PREDEVELOPMENT PLAN REVIEW COMMENTS

Project Number: PPR2021-00007

Project Address: 2021 E. Colorado Blvd.

Review of preliminary plans for the construction of a new mixed-use project (193 residential units, 15,200 square feet of commercial space). The parcel is currently developed with 27,002 square feet of commercial space, surface parking, and one residential unit. The subject property is zoned ECSP-CG-4 and RM-32, with a Low Mixed Use General Plan Land Use Designation.

Figure 1: Project Site

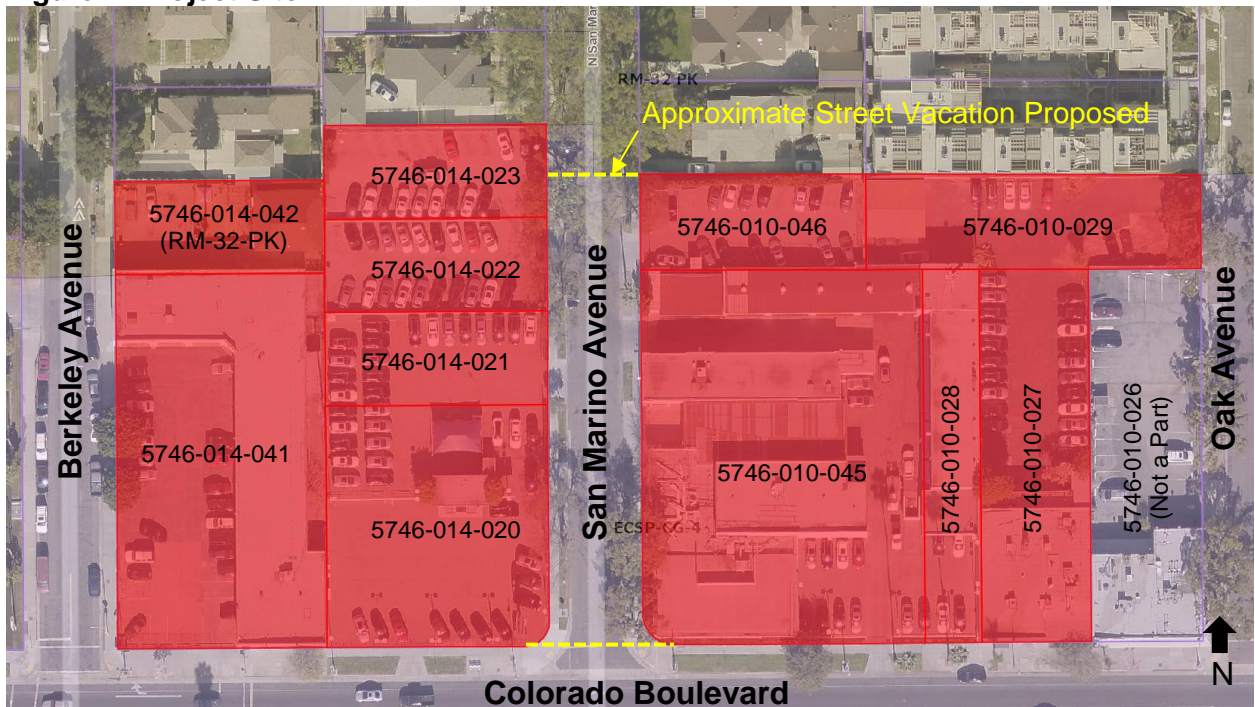
According to the plan, the aggregate project site consists of 135,304 square feet. As part of future submittals, the applicant shall identify separately the land area devoted to the RM-32-PK zone, the ECSP-CG-4 zone, and the portion of San Marino Avenue to be vacated. Further, the cover sheet of plans references 12 parcels. Parcel 5746-010-026 is not a part according to site and floor plans and shall be omitted if not a part.

Figure 3: Required Setbacks

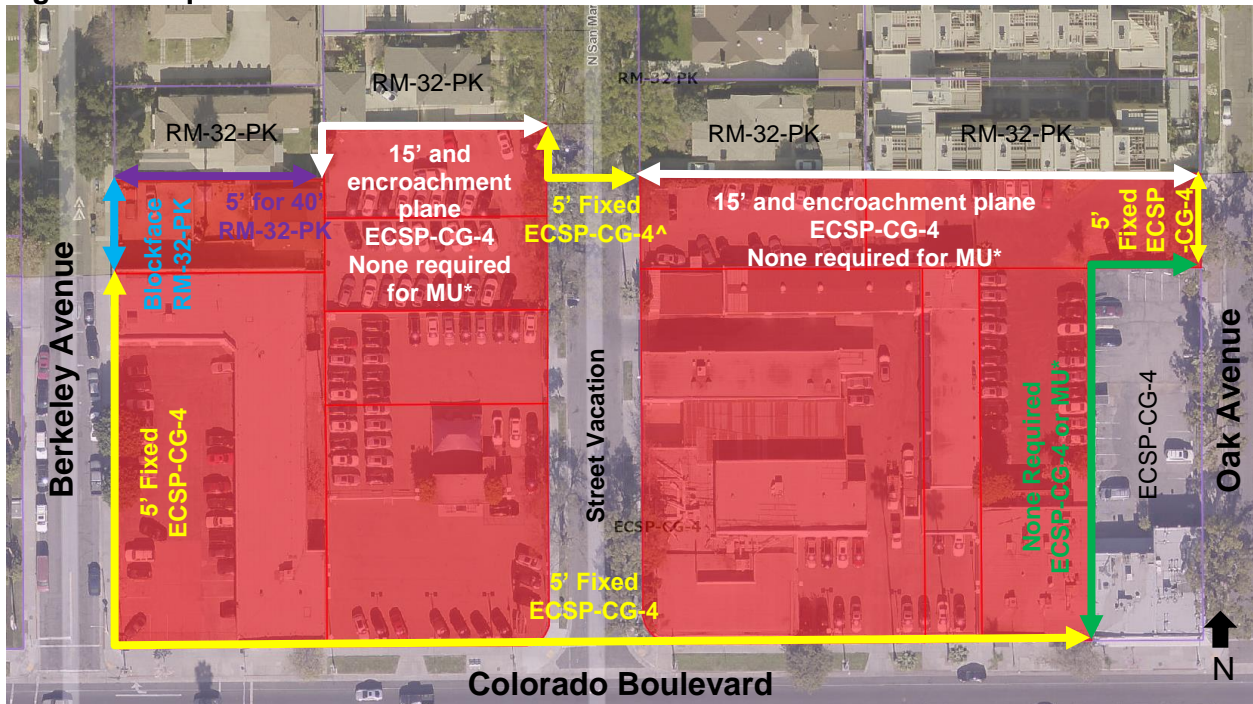
The ground floor along Colorado Boulevard is setback five feet, with the exception of a central retail element that is setback more than five feet to allow for an area identified as an outdoor plaza. Above the ground floor, portions of the building are built to the Colorado Boulevard property line and provide no setback. A zero setback does not comply.

The ground floor along Berkeley Avenue is largely setback five feet, with the exception of the southwest corner that is setback further. The floors above provide the same setbacks as the ground floor. There is not enough information to determine whether the additional setback at the southwest corner complies. The setbacks proposed from Oak Avenue and San Marino Avenue exceed five feet and do not appear to satisfy the requirements for a larger setback.

The north property line of the subject site abuts an RM-32-PK zone. The applicant has proposed a 15-foot setback. This distance would comply with both ECSP and mixed-use requirements, whichever is applicable. There is not enough information to determine whether the project complies with the encroachment plane requirement, where applicable. The abutting northerly lots are not used for parking.

Future submittals shall reference lot lines, easements, dedications and setbacks at each level. The plan shall also include a front setback calculation and exhibit to verify compliance with the RM-32-PK requirement.

Figure 4: Height

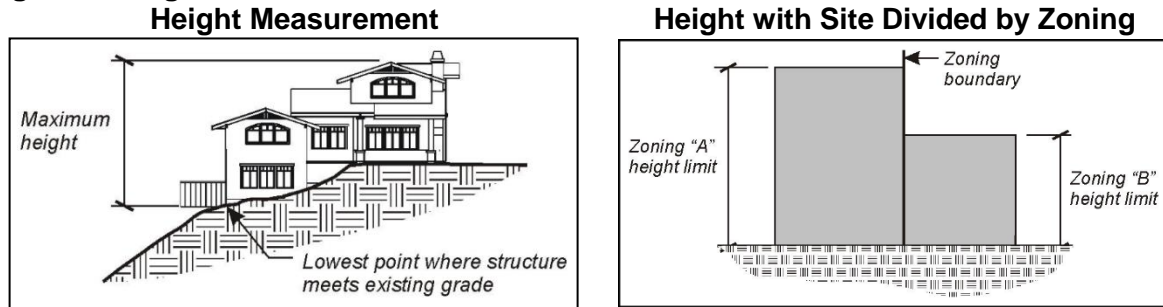
According to the plan the roof of the building reaches four stories and 40 feet tall. No information was provided referencing the lowest elevation of existing grade for measurement of height. Additionally, there is not information to determine whether the 40-foot height is measured to the highest point of the building. At a maximum of 40 feet, the building would comply with height limit in the ECSP-CG-4 zone. Within the portion of the site zoned RM-32-PK, the building does not comply. A 40-foot height exceeds the maximum for top plate and overall height.
